# ZONING DIVISION STAFF REPORT

PREPARED FOR THE URBAN DESIGN COMMISSION

**Project Address:** 515 Pinney Street  
**Project Name:** 515 @ Royster  
**Application Type:** Approval for Comprehensive Design Review of Signage  
**Legistar File ID #** [67175](#)  
**Prepared By:** Chrissy Thiele, Zoning Inspector  
**Reviewed By:** Matt Tucker, Zoning Administrator

2 FIRST FLOOR - OVERALL PLAN  
A-0.1 1/16" = 1'-0"

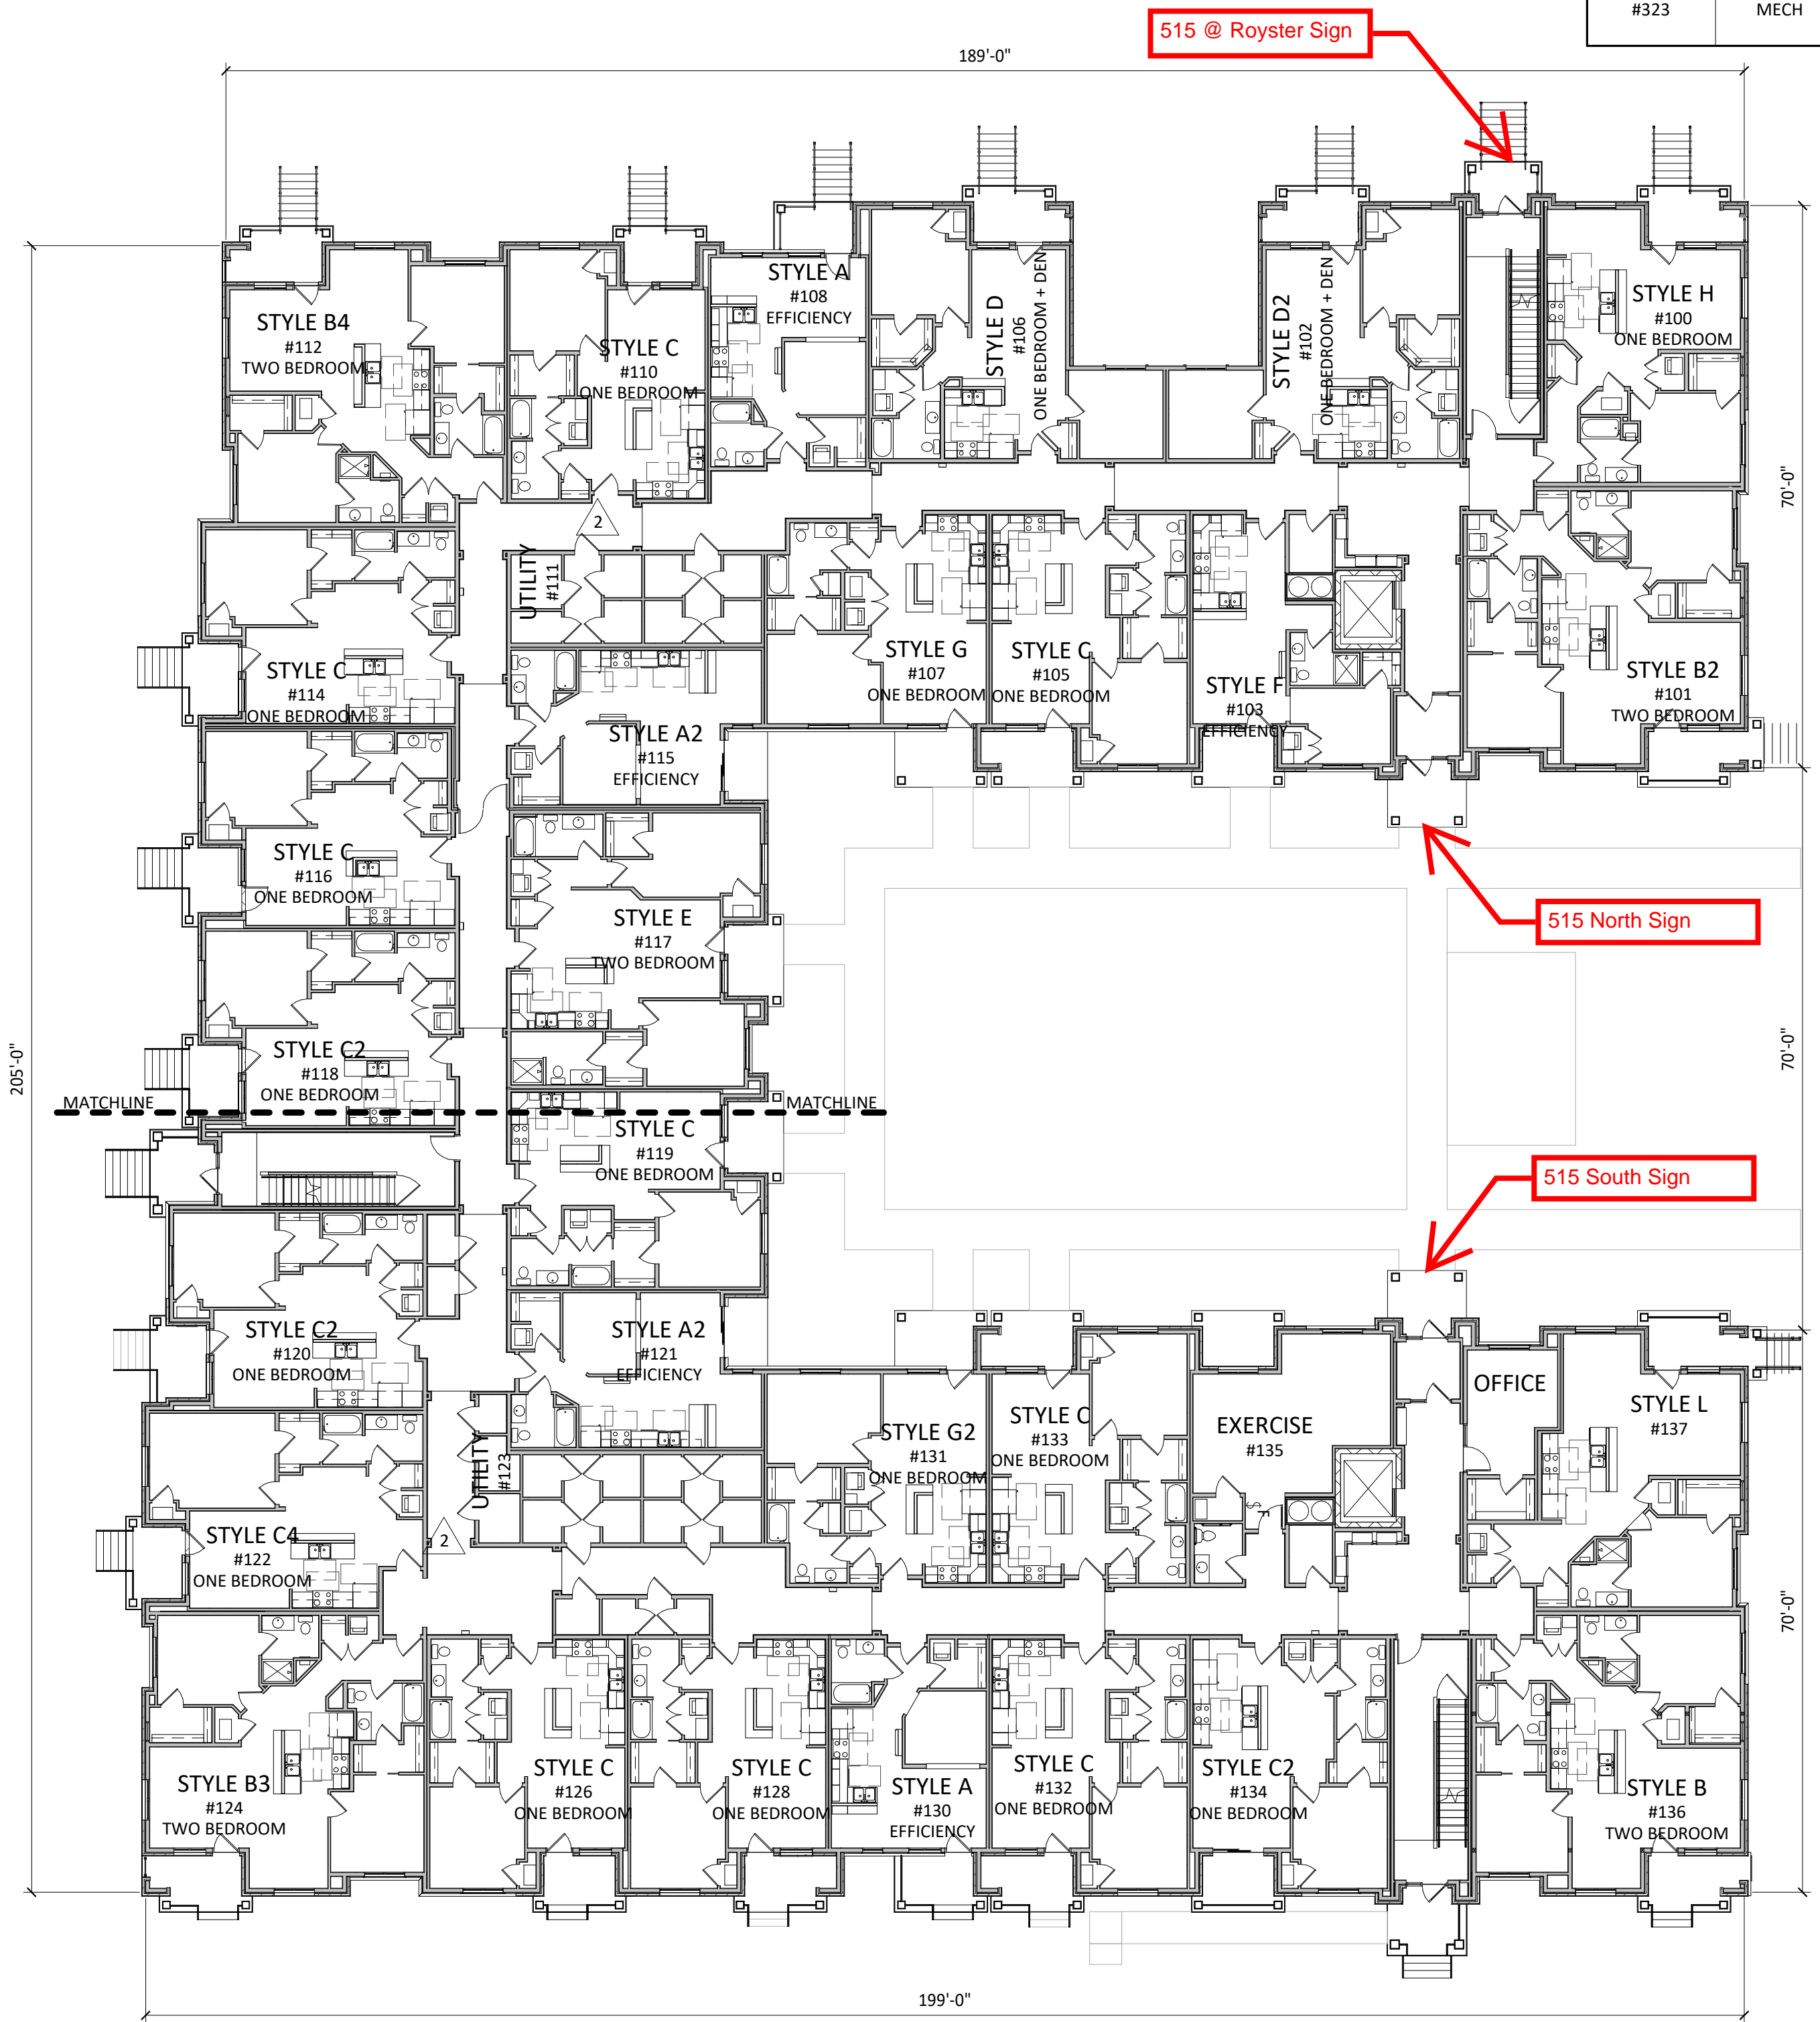
The apartment building was designed to have two primary entrances (see attached floor plan). One is located on the north interior courtyard and the other is on the south interior courtyard. The applicant is requesting for both of these entrances to have the above canopy signs, which will note the designated north and south entrances, in order to guide tenants and visitors to the appropriate entrance, as well as assist with mail/package delivery, as each entrance has its own mailbox and intercom system. The third above canopy sign the applicant is requesting is located above a private entrance/exit door that leads to a stairwell for the apartment building. This is not a public entrance, and visitors will not be able to freely enter the building from this location. The applicant states the sign is needed so visitors can identify the building is 515 Pinney Street and not 515 Grand Oak Trail. Between the two style options provided (one being non-illuminated and 2' tall and the other internally illuminated and 2' 9" tall), the applicant does not provide a preference of one over the other. Note: At the Sept. 22<sup>nd</sup> UDC meeting,

It is reasonable to desire signage over the primary entrance to a building, especially when the primary entrance are not located where visitors would expect them to be, or where there are multiple primary entrances. However, Staff has concerns about the internally illuminated signs, since the signage will face the interior courtyard for the apartment, and how it could affect the residential units with windows facing the courtyard at night. Staff has reviewed the site plans submitted for zoning approval, and it is shown that lighting will be provided in the interior courtyard. Therefore, staff feels that the non-illuminated option to be sufficient, illumination not necessary. **Note: It is noted Sept. 22<sup>nd</sup> UDC staff meeting that Commissioners recommended non-illuminated signs in the courtyard.**
